**PLAN 2**

**PLANNING APPLICATION PLN-19-0034**

**59 RAEBURN ROAD & ACCESS OVER 827,831 & 833 HOBART ROAD, BREADALBANE**

**ATTACHMENTS**

CONSTRUCTION AREA PLAN

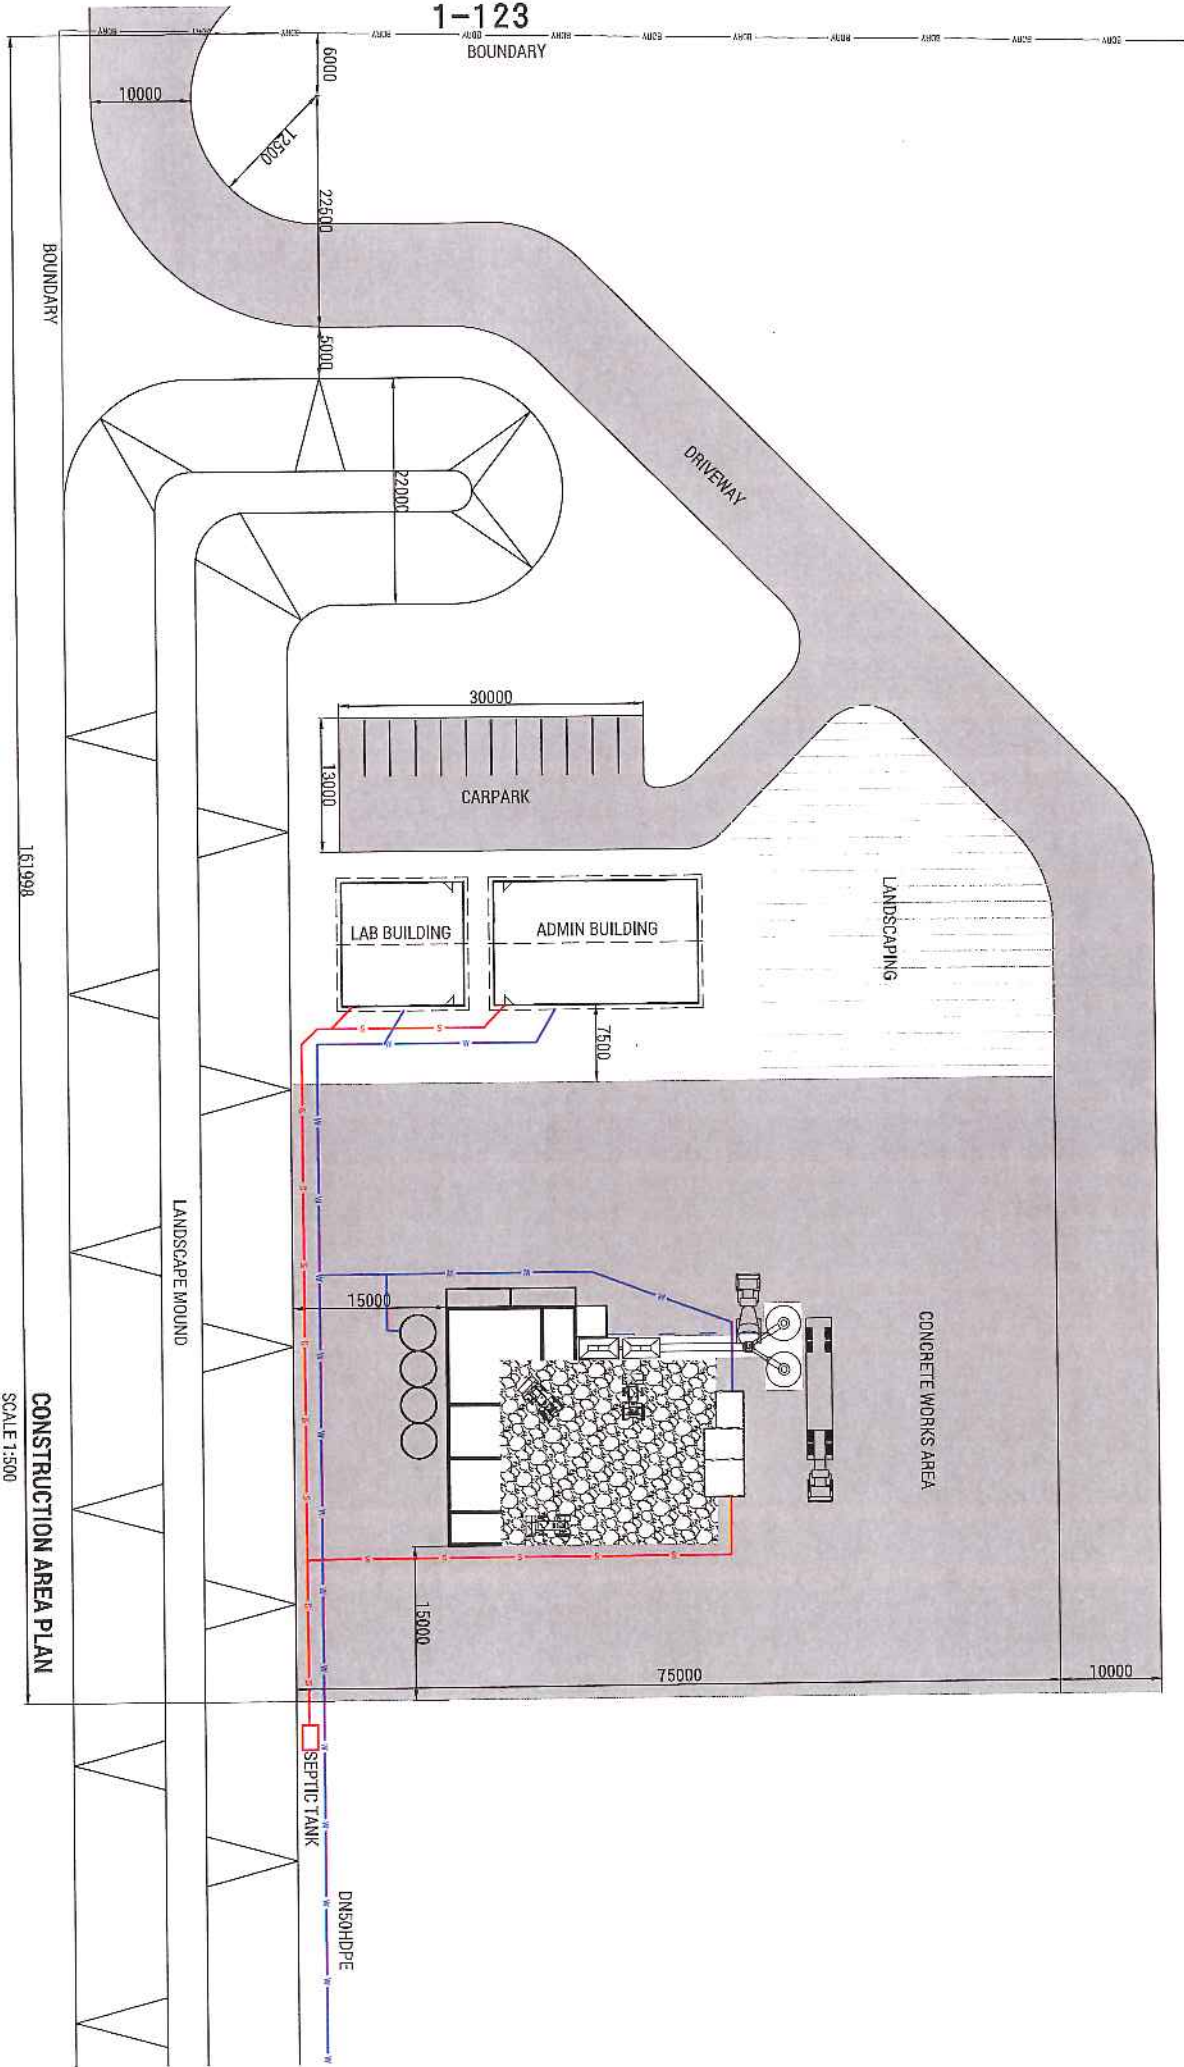
From the material provided it is not possible to ascertain compliance with Clause E6.7.2 A2,1 as the dimensions of the car parking spaces are not annotated on the plans.
